**Re: Product Change Notification for Harwin packaging.**

Please be advised that the pick and place cap used on male Datamate connectors (M80 Series) has been changed from a plastic cap to a metal stamped cap. This reverses a previous PCN dated 8<sup>th</sup> January 2020, following further investigation and improvement of the previous metal cap design.

*Left = Previous plastic cap, Right = New metal cap*

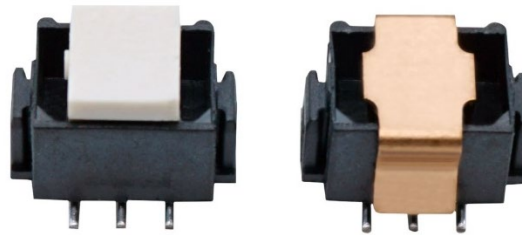
As you can see from the profiles, a small amount of height has been reduced, and changes to the settings on your pick and place machines may be required.

The connector design itself is unchanged. Please note that we are no longer prepared to supply the plastic cap once stock of the existing packaging is exhausted.
